Project
East West Rail (Western Section) Phase 2

Drawing Title
PASSING PLACE A3_P_7 GENERAL ARRANGEMENT

Stage 2 Road safety audit response report

Offline Highways Passing Places – Package 2 – Oxfordshire (A3 Marsh Gibbon – Compound Access)

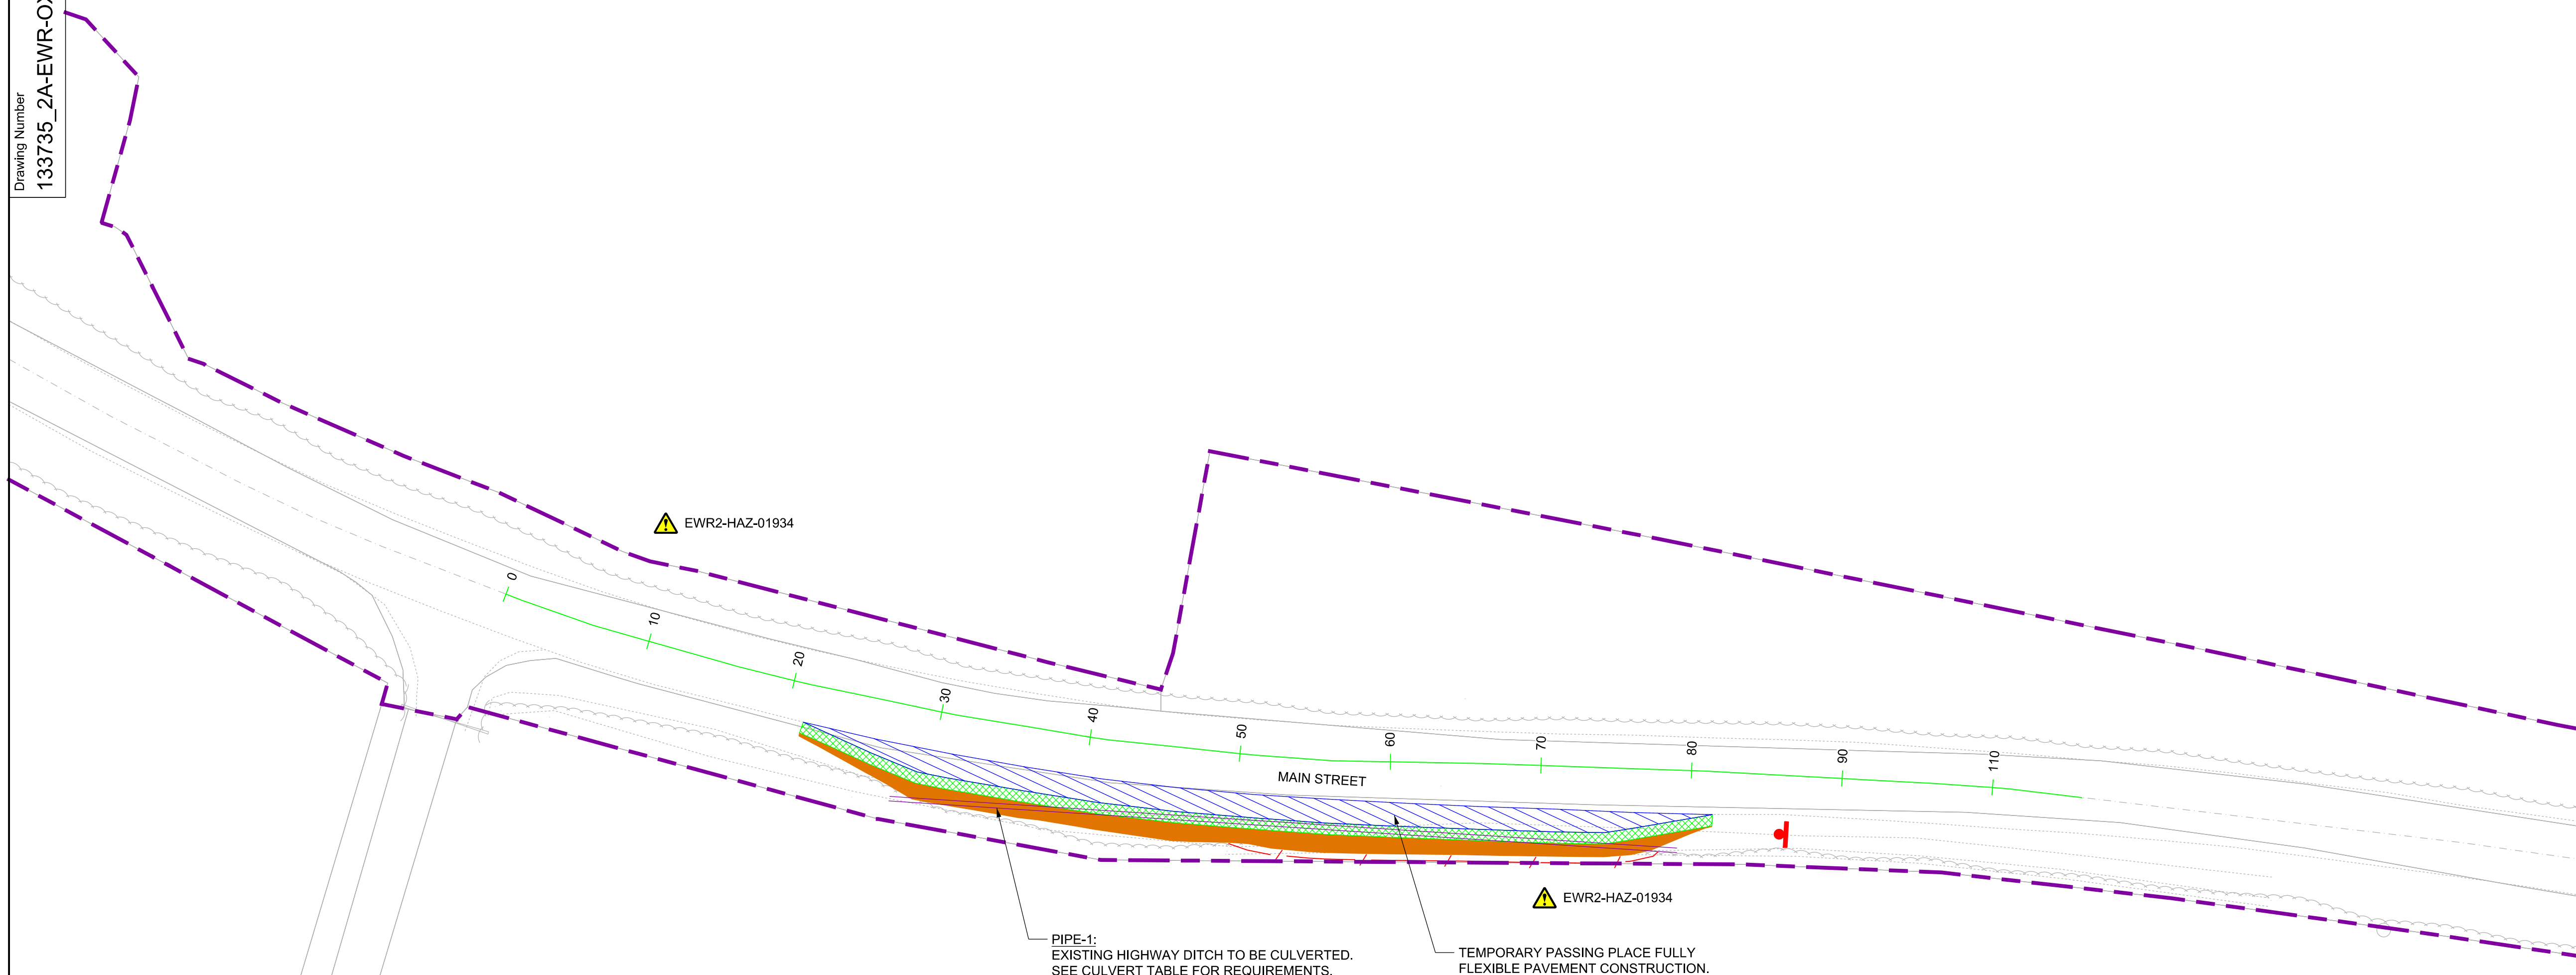
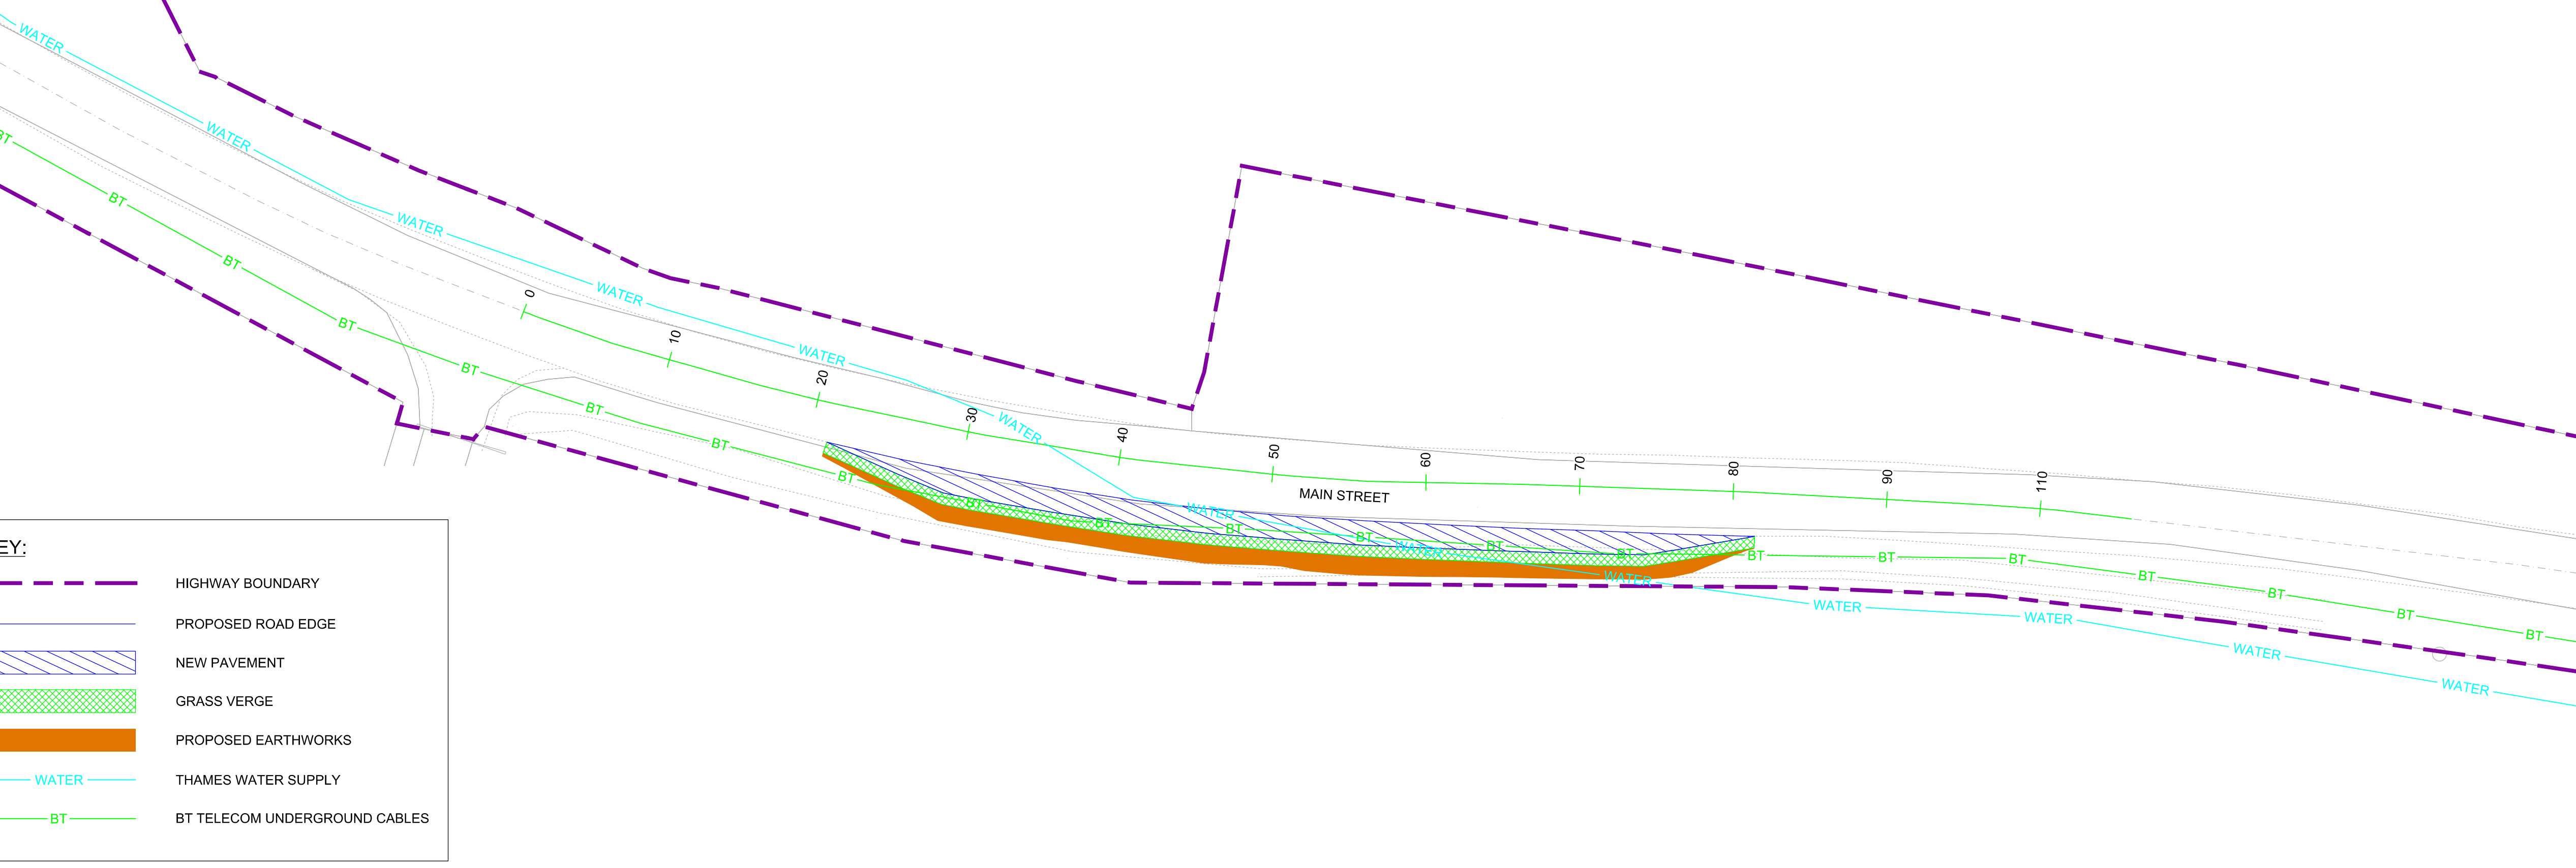
Location: Passing Places A2-P-1, A3-P-2, A3-P-3, A3-P-5, A3-P-7 and A3-P-10. Unnamed Road (towards Mill Road) and Unnamed Road.

Summary: Proximity of passing place to farm traffic access increases risk of collision. There are accesses used by farm traffic along the Unnamed Road (towards Mill Road). As a farm vehicle enters or exits these accesses from Unnamed Road (towards Mill Road), there is a likelihood that a construction vehicle may collide with it as they may not anticipate the turning farm vehicle, particularly when they are preparing to enter the passing place. This issue is exacerbated by the presence of vegetation around these accesses which reduces the visibility between farm traffic and construction drivers using the Unnamed Road (towards Mill Road).

Location: Passing Places A2-P-2, A3-P-2, A3-P-3, A3-P-4, A3-P-5, A3-P-6, A3-P-7, A3-P-8, A3-P-9 and A3-P-10.

Passing places are proposed in positions where vegetation may restrict drivers' visibility of the route and the visibility of vehicles using the passing places. With this limitation, drivers of construction vehicles may not be aware that they should wait and might proceed, increasing the risk of side swipe collisions, or the risk of vehicles leaving the carriageway

RSA Ref	Location	RSA Problem	RSA Recommendation	Design Team Response	Network Rail Response	Agreed RSA action
2.4	<p>Passing Places A2-P-1, A3-P-2, A3-P-3, A3-P-5, A3-P-7 and A3-P-10. Unnamed Road (towards Mill Road) and Unnamed Road.</p>	<p>Proximity of passing place to farm traffic access increases risk of collision There are accesses used by farm traffic along the Unnamed Road (towards Mill Road). As a farm vehicle enters or exits these accesses from Unnamed Road (towards Mill Road), there is a likelihood that a construction vehicle may collide with it as they may not anticipate the turning farm vehicle, particularly when they are preparing to enter the passing place. This issue is exacerbated by the presence of vegetation around these accesses which reduces the visibility between farm traffic and construction drivers using the Unnamed Road (towards Mill Road).</p>	<p>Provide traffic signing to warn of construction passing places and farm traffic accesses. Trim back vegetation around the accesses to maximise intervisibility</p>	<p>Accept the RSA problem and recommendation made by the RSA team. The design includes a signage strategy which provides signs to notify drivers that the road has passing places. The site clearance drawings include vegetation clearance to achieve required visibility and signage strategy drawings likewise include this provision.</p>	Accepted	Proceed as Design Team Response

2.5	<p>Passing Places A2-P-2, A3-P-2, A3-P-3, A3-P-4, A3-P-5, A3-P-6, A3-P-7, A3-P-8, A3-P-9 and A3-P-10. Unnamed Road (towards Mill Road) and Unnamed Road.</p>	<p>Driver visibility reduced by vegetation Passing places are proposed in positions where vegetation may restrict drivers' visibility of the route and the visibility of vehicles using the passing places. With this limitation, drivers of construction vehicles may not be aware that they should wait and might proceed, increasing the risk of side swipe collisions, or the risk of vehicles leaving the carriageway on narrower sections of carriageway. Additionally, drivers of approaching vehicles may not anticipate the construction vehicle leaving the passing place, leading to side swipe or head on collisions. There is further risk that existing vegetation will encroach into the carriageway increasing the risk of damage to vehicles and HGVs being pushed towards oncoming traffic.</p>	<p>The existing vegetation should be cut back to ensure clear visibility to all traffic signs and to keep the carriageway clear from obstructions.</p>	<p>Accept the RSA problem and recommendation made by the RSA team. The site clearance drawings include vegetation clearance to achieve required visibility and signage strategy drawings likewise include this provision.</p>	Accepted	Proceed as Design Team Response
